**RE: Westmount Development Revised Sketch Plan**

**WAIVER REQUESTS**  
**FOR**  
**WESTMOUNT DEVELOPMENT**  
**REVISED SKETCH PLAN**  
MOUNT JOY TOWNSHIP, LANCASTER COUNTY, PA  
May 5, 2023  
REV. July 10, 2023  
REV. February 2, 2024

Re: Revised Sketch Plan for Westmount  
Our File No. 10221-1

Re: Westmount  
Final Land Development Plan  
Township Permit No. 23-07-FLDP  
LCEC Project No: 25-134

**REVISED SKETCH PLAN**  
SUBJECT:  
**LOT ADD-ON & SUBDIVISION PLAN**  
FOR  
WESTMOUNT  
MOUNT JOY TOWNSHIP, LANCASTER COUNTY, PENNSYLVANIA  
CLIENT:  
**VISTABLOCK, LLC**  
150 FARMINGTON LANE  
LANCASTER, PA 17601  
717-682-8775

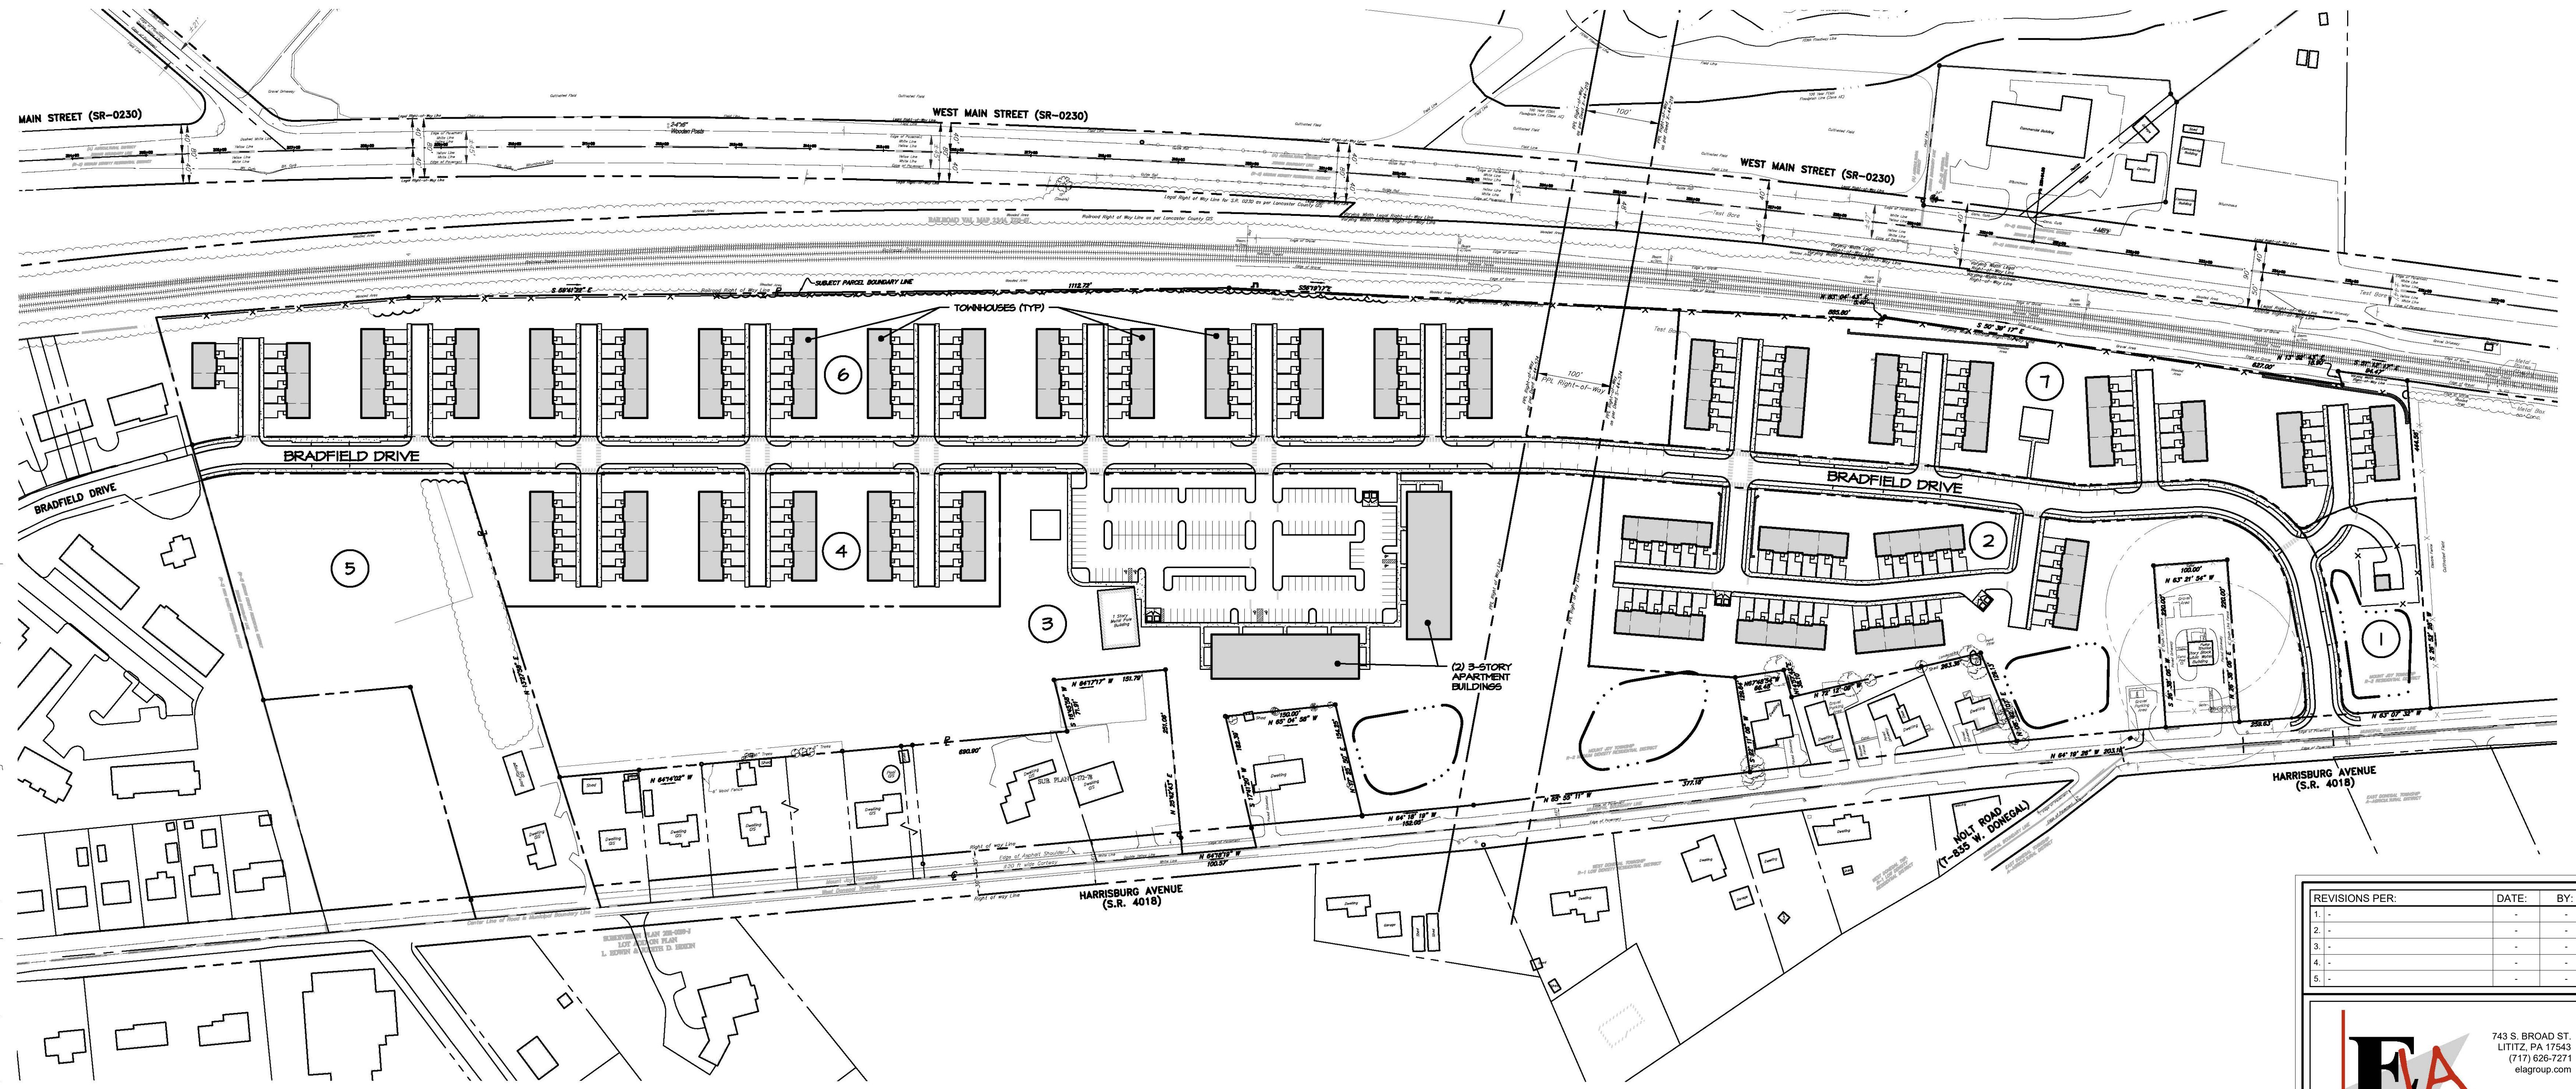
The Sketch Plan proposes to subdivide the adjoining lot of Henry Werner and Christina Werner identified as 1759 Harrisburg Avenue (the "Werner Lot") so that the Werners will retain the portion of their lot with frontage on Harrisburg Avenue and Vistablock will acquire the rear of the Werner Lot to enable it to connect to and extend Bradfield Drive. This change eliminates the cul-de-sac street system proposed on the 2023 Plan.

If the Planning Commission approves a revised final plan showing a subdivision of the Werner Lot, the Planning Commission should condition its approval on the Werners recording a deed for their diminished lot identified as Lot 5 on the Sketch Plan with a perimeter legal description. The Werners will have to be parties to the Storm Water Management Agreement for any plan since at the time the plan is recorded they will be the record owners of land on which the extension of Bradfield Drive and storm water management facilities will be located.

REVISED SKETCH PLAN  
SUBJECT:  
**OVERALL SITE LAYOUT PLAN**  
FOR  
WESTMOUNT  
MOUNT JOY TOWNSHIP, LANCASTER COUNTY, PENNSYLVANIA  
CLIENT:  
**VISTABLOCK, LLC**  
150 FARMINGTON LANE  
LANCASTER, PA 17601  
717-682-8775

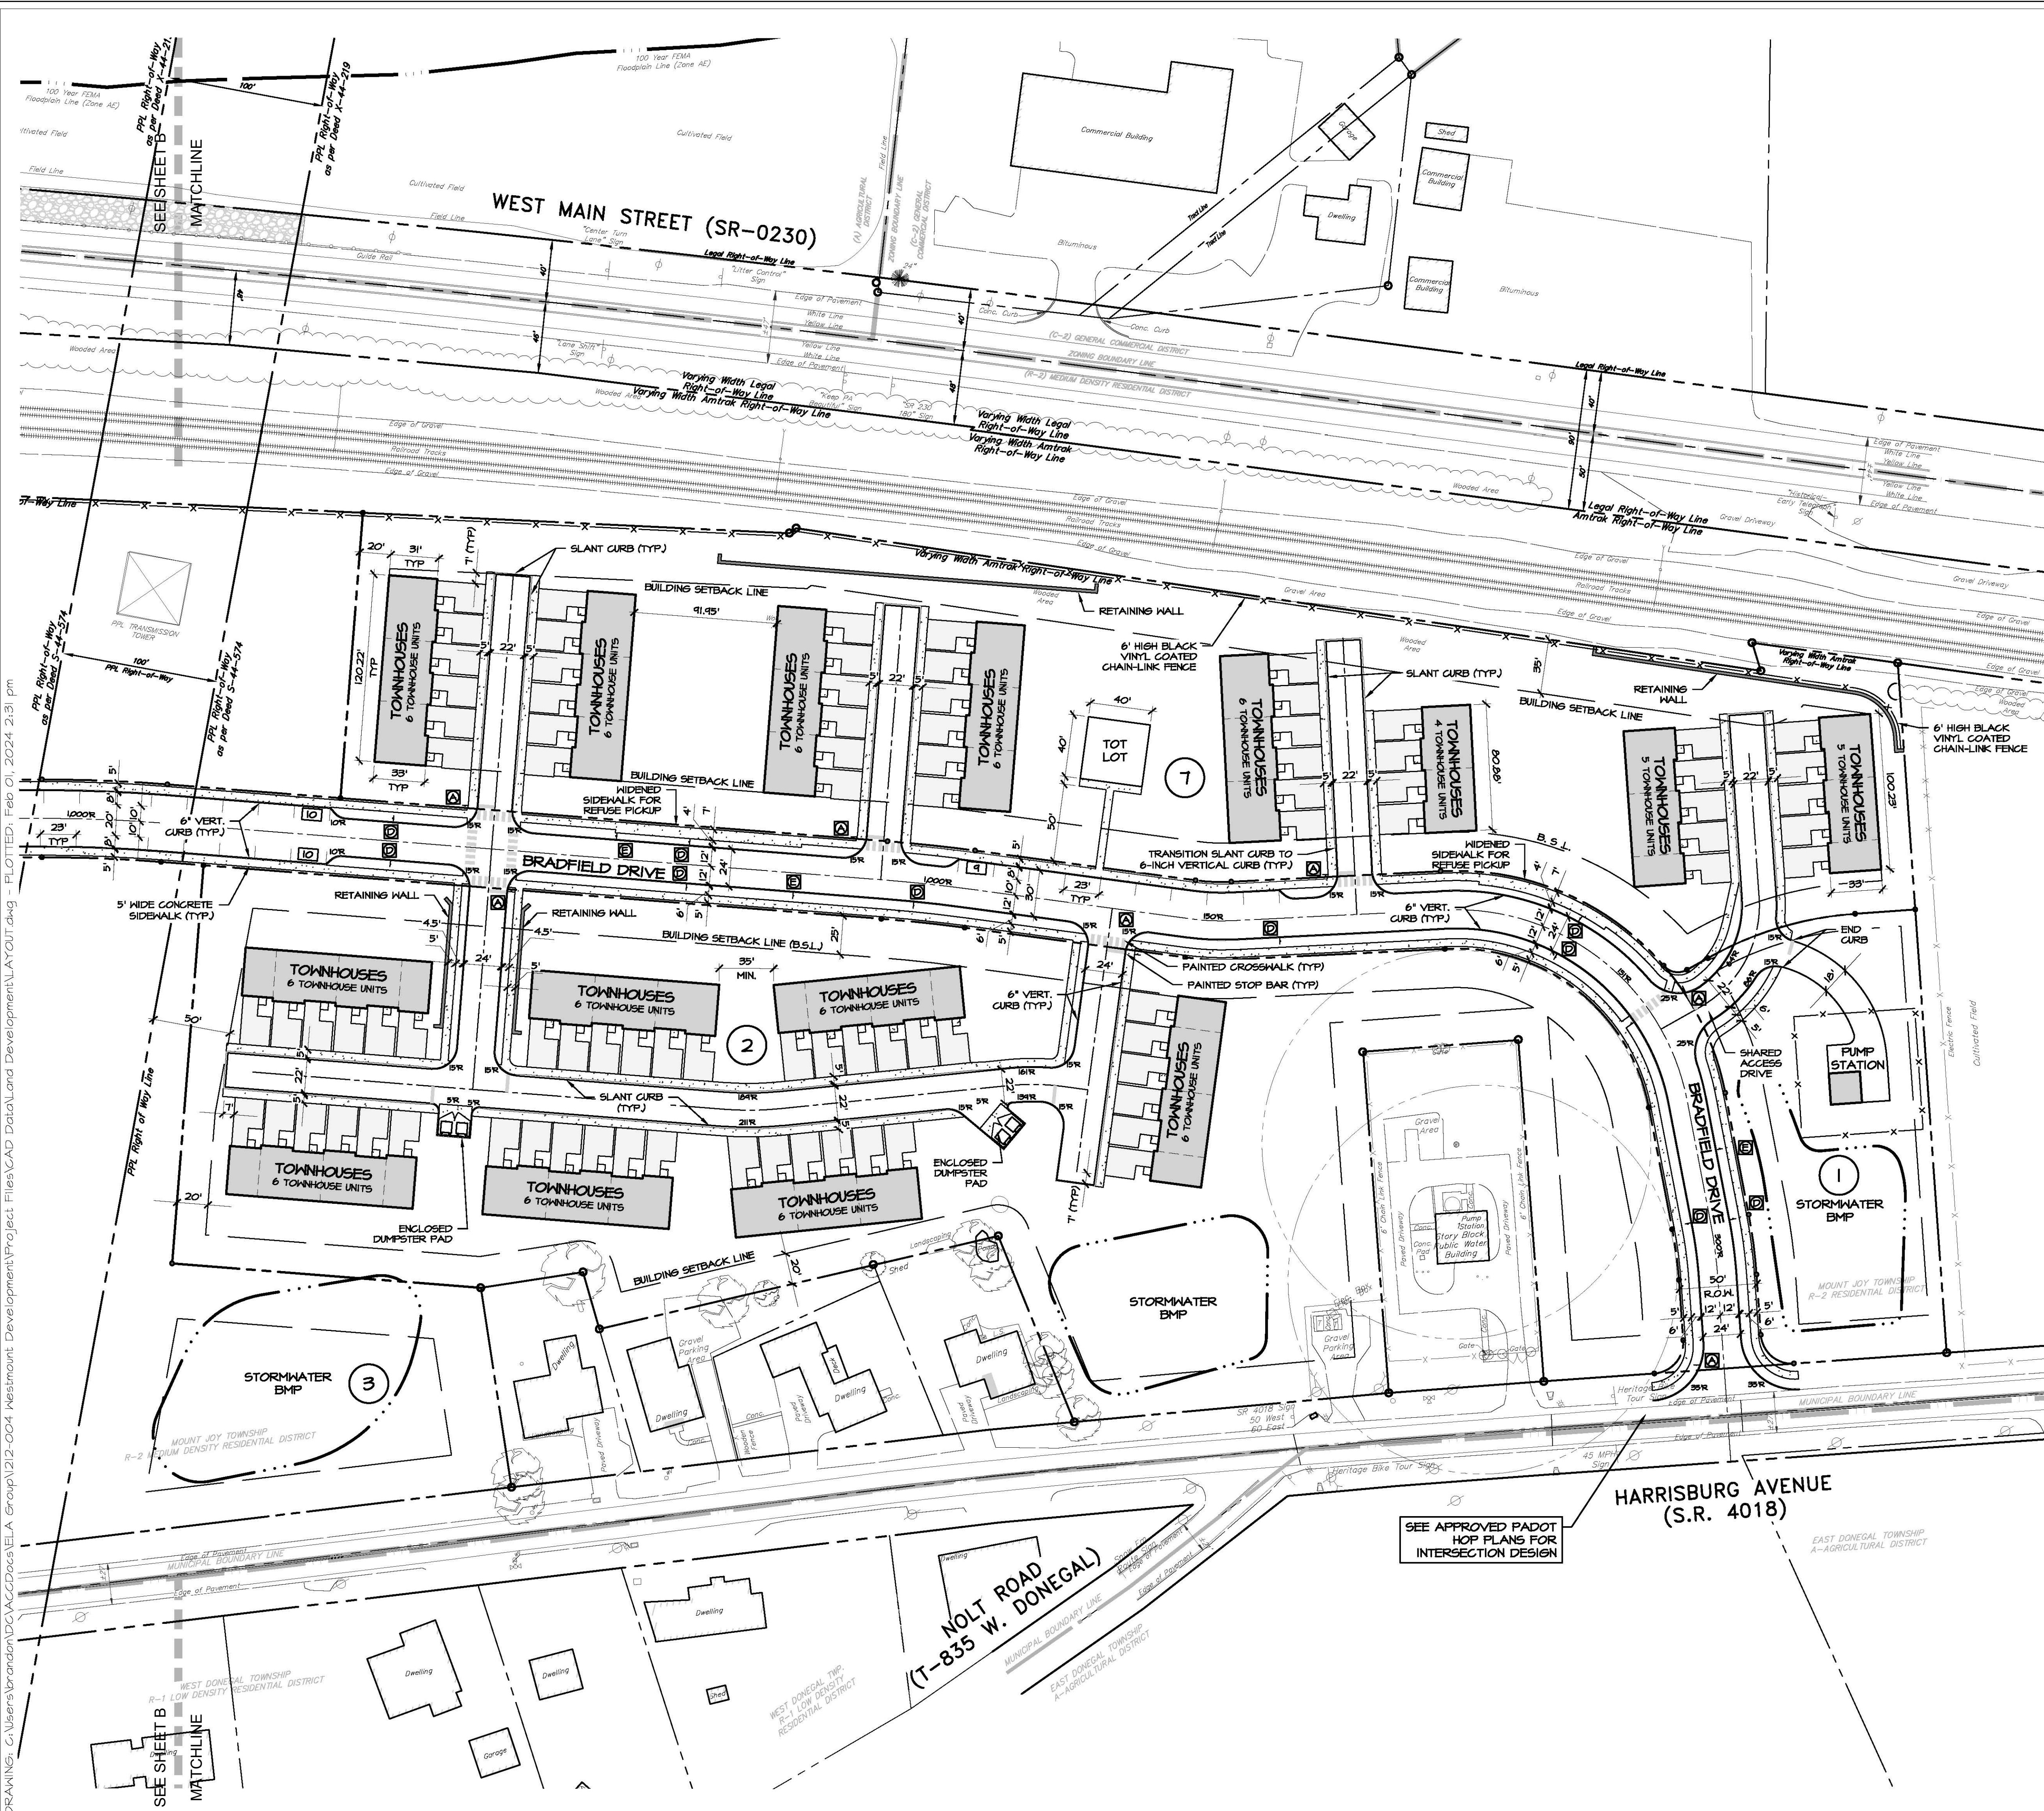
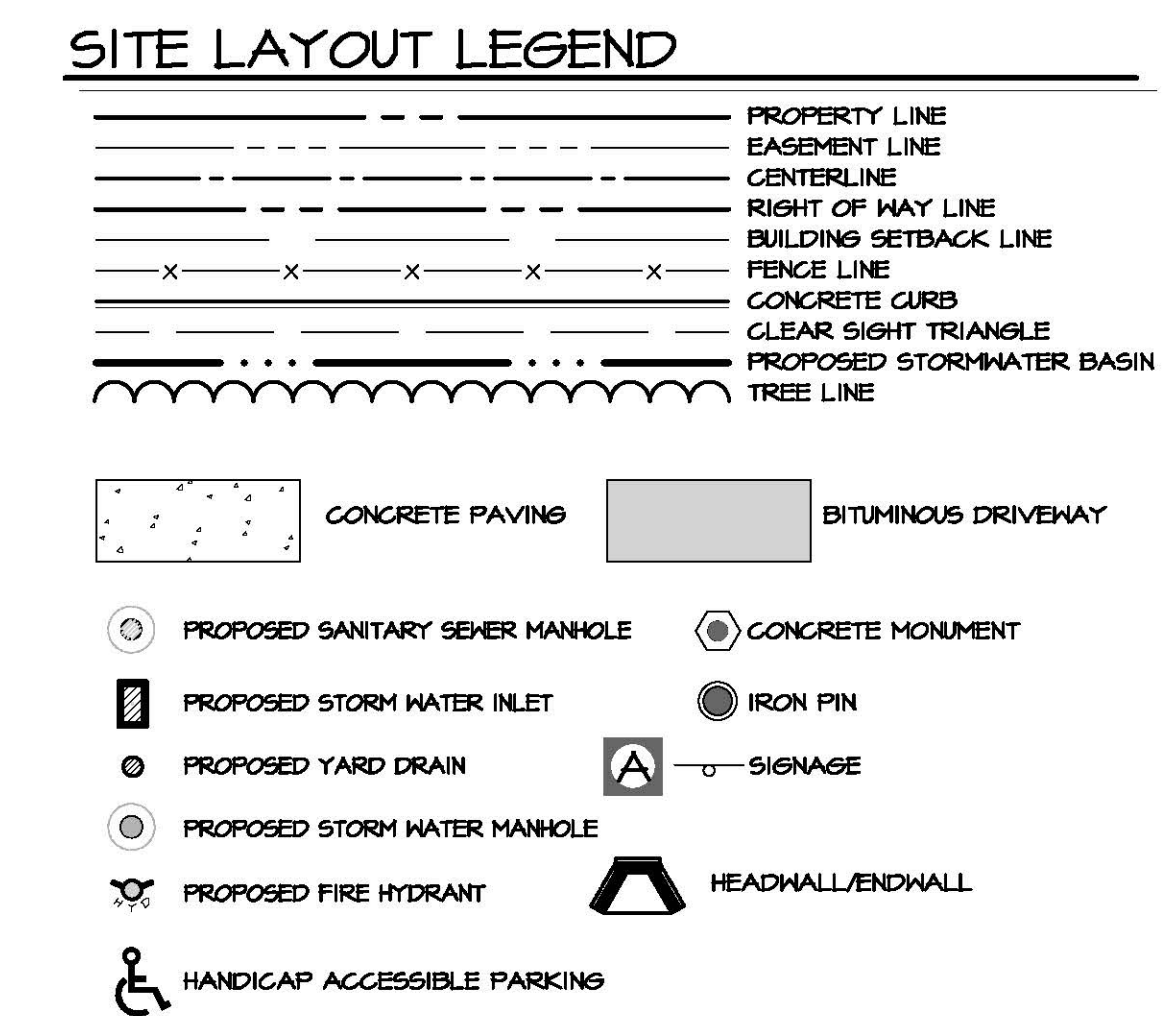
The parking data on the cover sheet of the Sketch Plan is incorrect. It states that there are 428 spaces for the townhouse dwellings, three spaces per unit identified as two in the driveway and one in the garage. The Sketch Plan proposes stacked parking. The Zoning Ordinance does not permit stacked parking. See Zoning Ordinance §135-42.B. The Sketch Plan should properly identify the amount of off-street parking available.
